Project: 226052 DFCI-BIDMC New Cancer Hospital - 1 Joslin Place - Construction
1 Joslin Place
Boston, Massachusetts 02215

RFI #0-PB-26: P2.01 - 3" Cam Fitting Design Intent Confirmation

1 LEVEL 1 - DRAINAGE PLAN

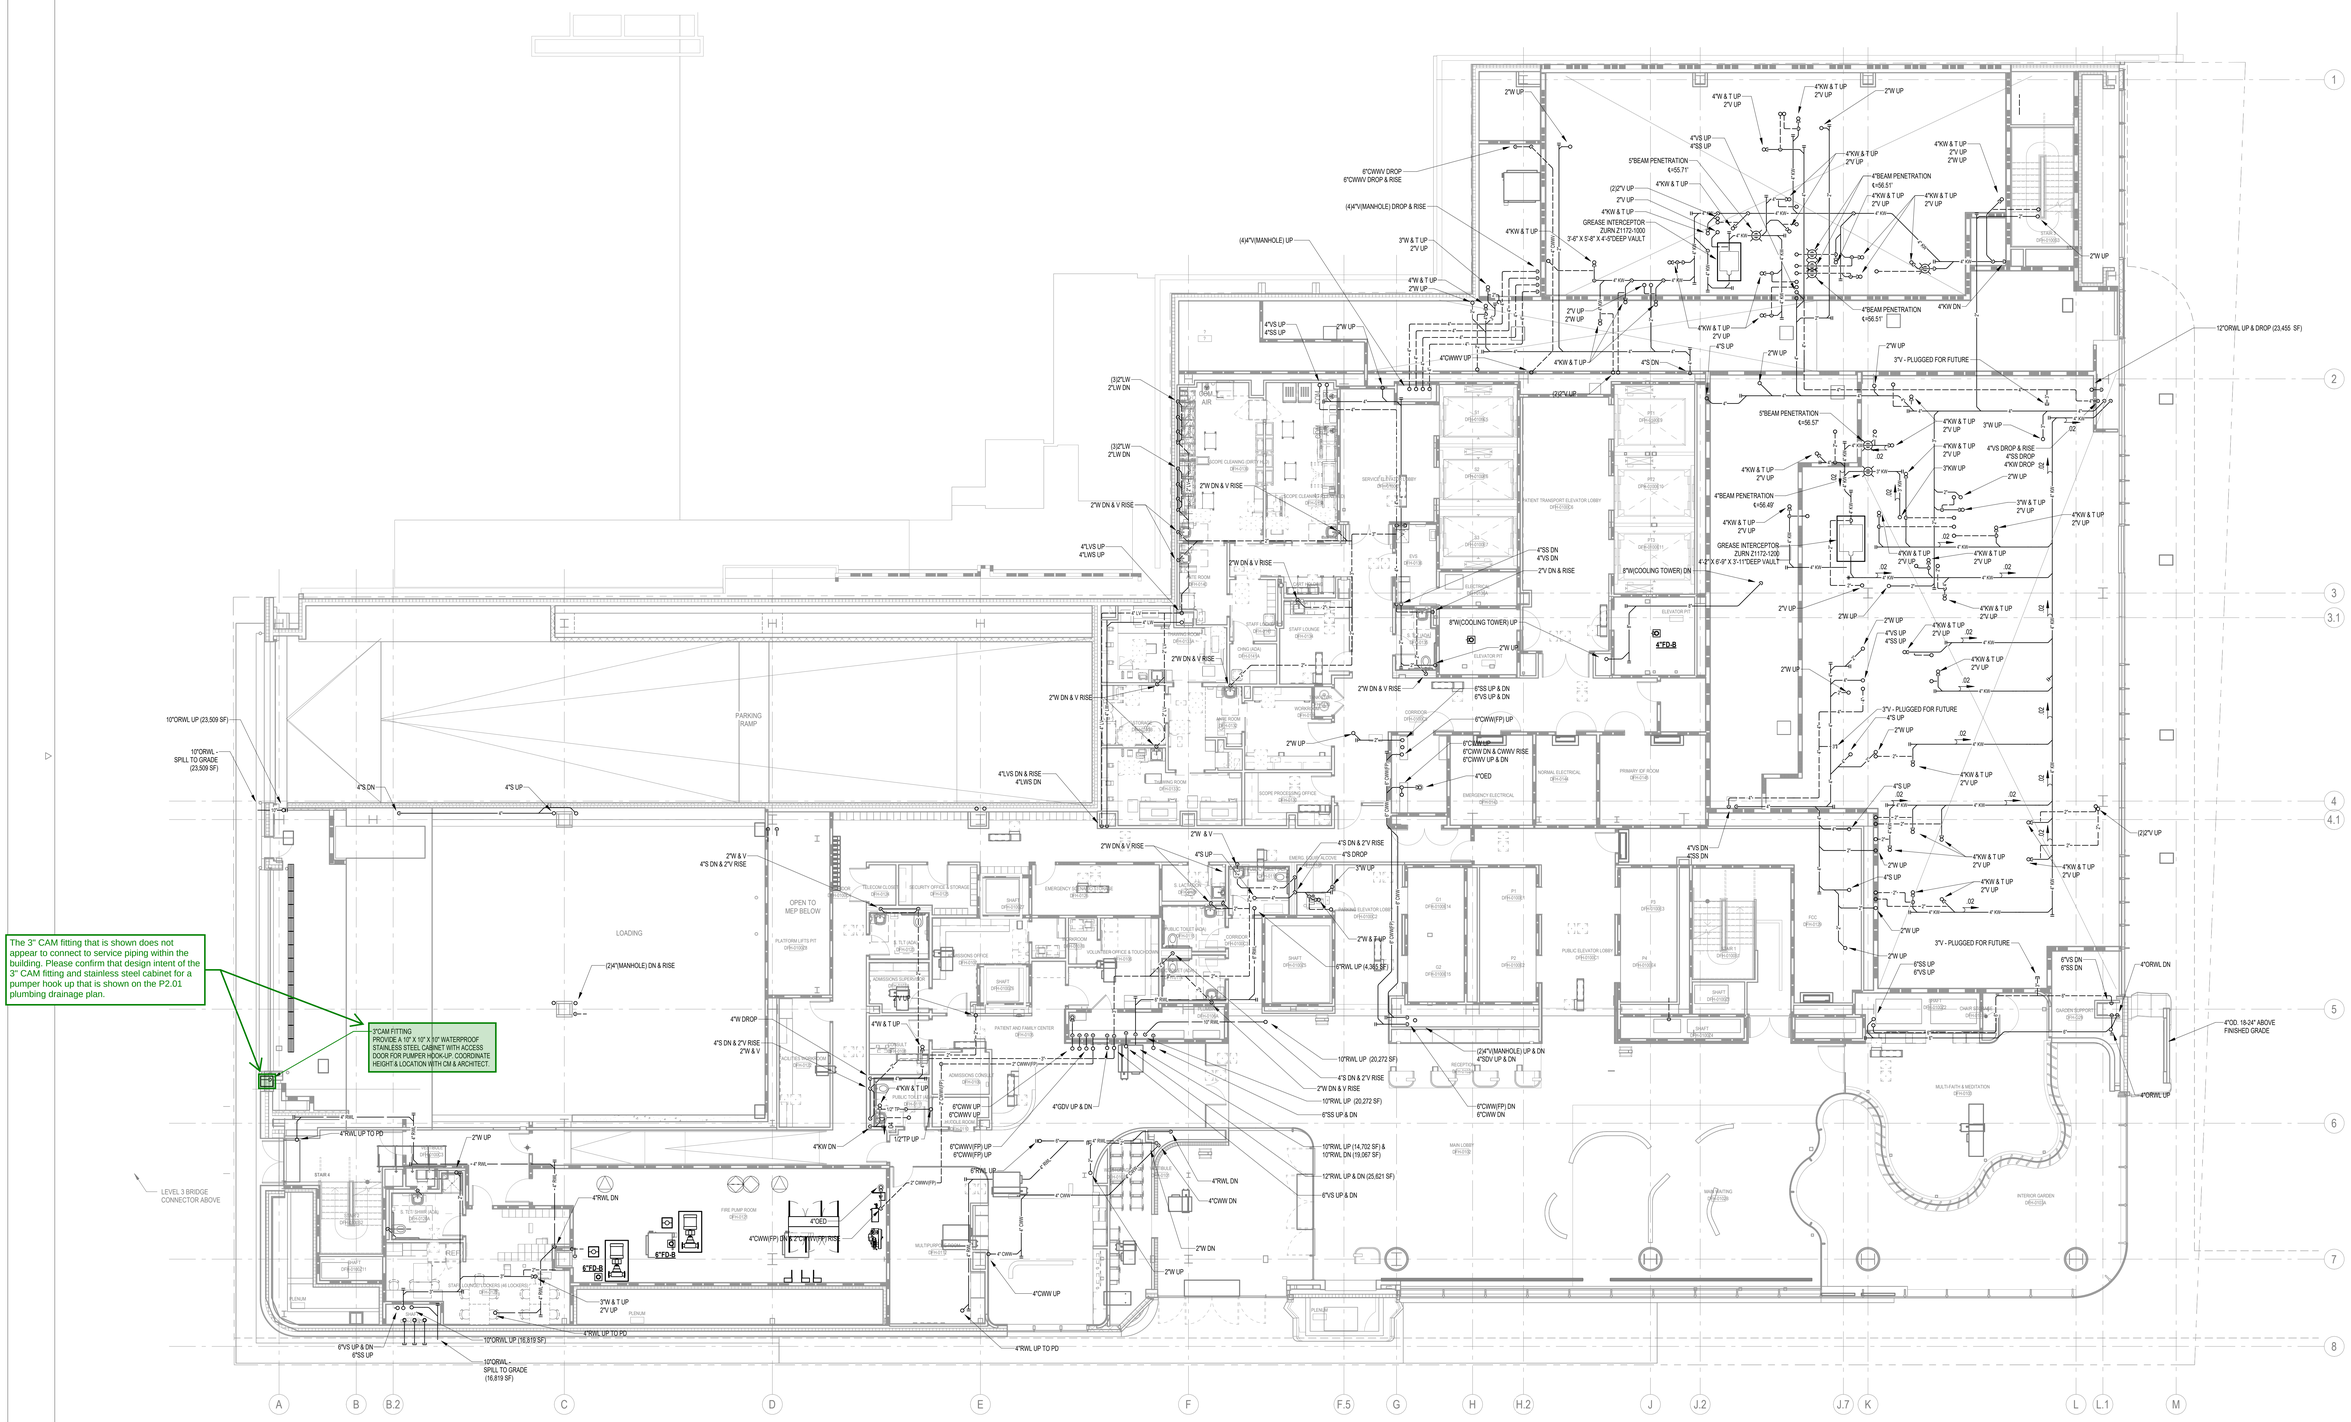
Please refer to the attachment. There is a 3" CAM fitting with a waterproof stainless steel cabinet for a pumper hook up shown on the P2.01 Plumbing Drainage Plan. The 3" CAM fitting that is shown does not appear to connect to service piping within the building. Please confirm that design intent of the 3" CAM fitting and stainless steel cabinet for a pumper hook up that is shown on the P2.01 plumbing drainage plan.

Per Payette 11/14 response: The 3" CAM fitting and Stainless steel cabinet are part of the grease pump discharge serving the grease interceptor located on P1.
Pipe connection to tank and notation for cabinet will be provided in 1/15 Addendum.
